7.0 Instrumentation and Control Systems

7.1 Introduction

The information in this section of the reference ABWR DCD, including all subsections and tables, and figures, is incorporated by reference with the following departures and supplements.

Figure 7.1-1 SSLC Self-Test System Diagnosis

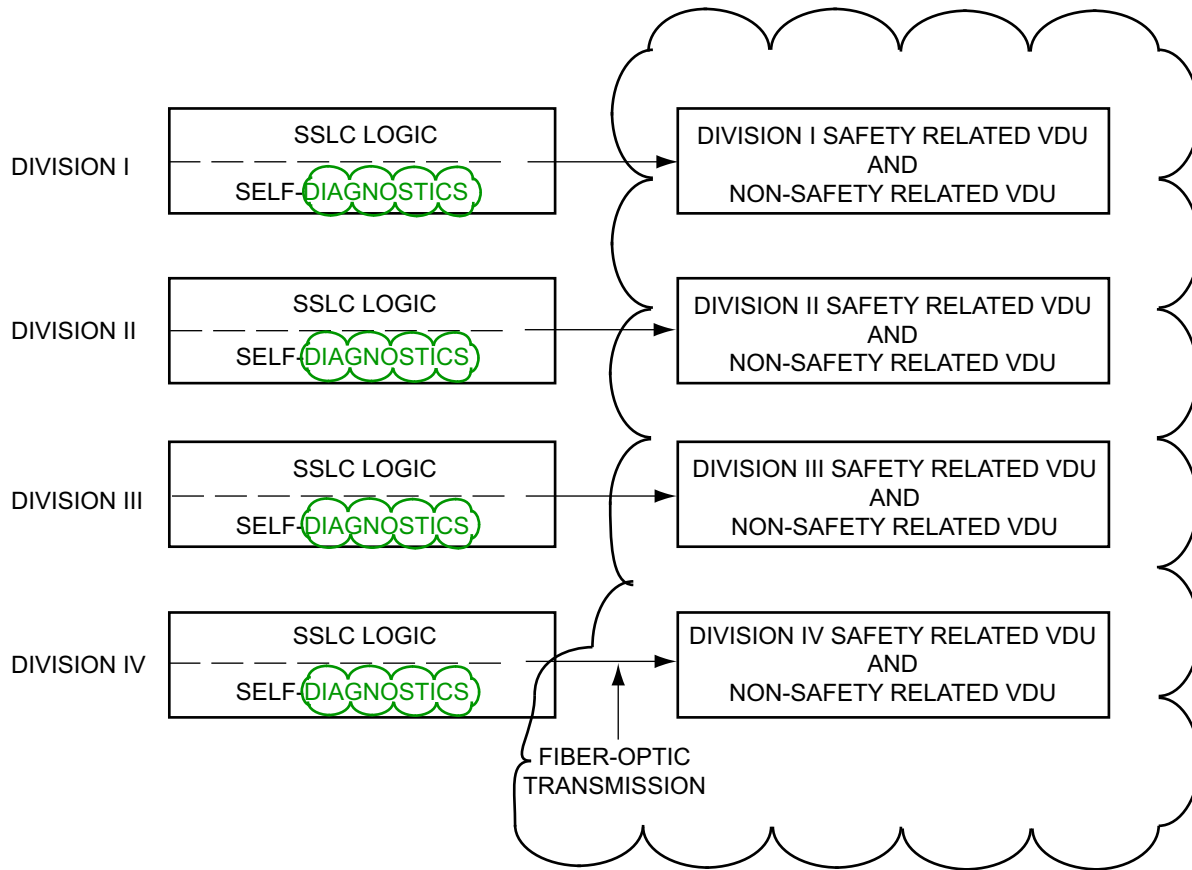
STD DEP T1 3.4-1 (Figure 7.1-1, 7.1-2)

The RPS and ESFELCS Systems can be tested during reactor operation ~~by six separate tests~~. The first five tests are primarily manual tests and, although each individually is a partial test, combined with the sixth test they constitute a complete system test. The sixth test is the self-test of the safety system logic and control which automatically tests the complete system excluding sensors and actuators.

The hierarchy of test capability is provided to ensure maximum coverage of all EMS ECF/SSLC functions, including logic functions and data communication links. Testing shall include:

~~Self-diagnosis includes monitoring of overall program flow, reasonableness of process variables, RAM and PROM and processor memory condition, and device interlock logic.~~ Testing includes continuous error checking of all transmitted and received data ~~on the serial data links of each SSLC controller;~~ for example, error checking by parity check, checksum, or cyclic redundancy checking (CRC) techniques.

~~Self-test diagnostic~~ failures (except intermittent failures) are annunciated to the operator at the main control room console and logged by the ~~process plant~~ computer. Faults are identified to the replacement board or module level and positively indicated at the failed unit.

Figure 7.1-2 Assignment of Interfacing Safety System Logic to SSLC Controllers

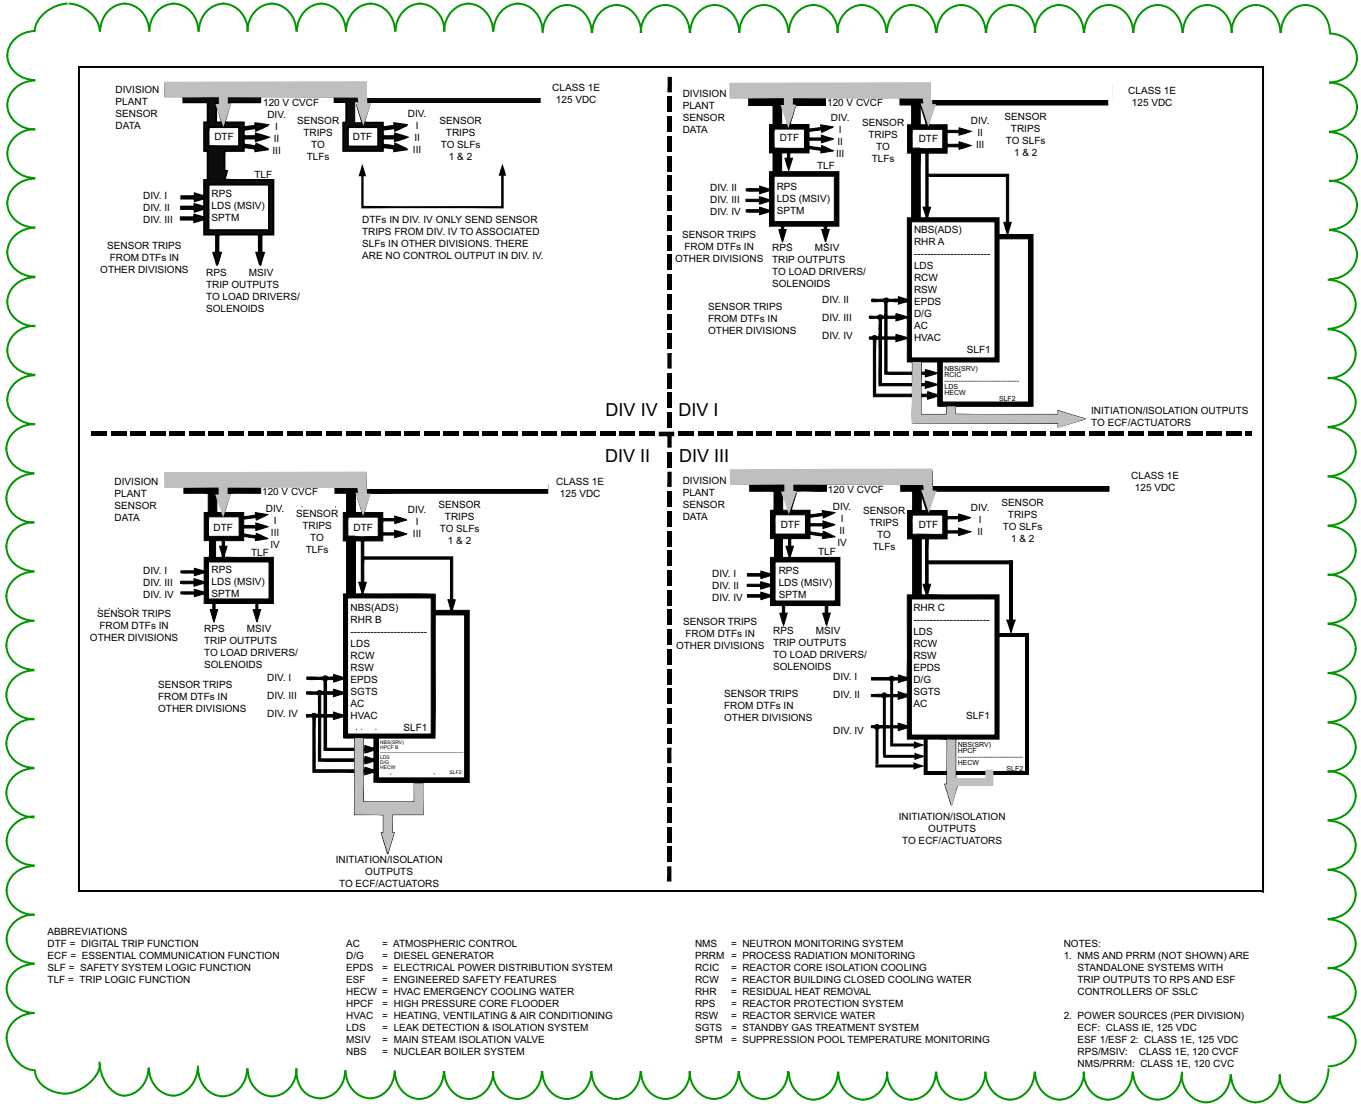
Divisional separation is also applied to the ~~essential multiplexing system (EMS)~~ Essential Communication Function (ECF) for Safety System Logic and Control (SSLC), which provides data highways for the sensor input to the logic units and for the logic output to the system actuators (actuated devices such as pump motors and motor-operated valves). Systems which utilize the SSLC are: (1) Reactor Protection (trip) System; (2) High Pressure Core Flooder System; (3) Residual Heat Removal System; (4) Automatic Depressurization System; (5) Leak Detection and Isolation System; (6) Suppression Pool Monitoring System; and (7) Reactor Core Isolation Cooling System. The equipment arrangement for these systems and other supporting systems is shown in Figure 7.1-2.
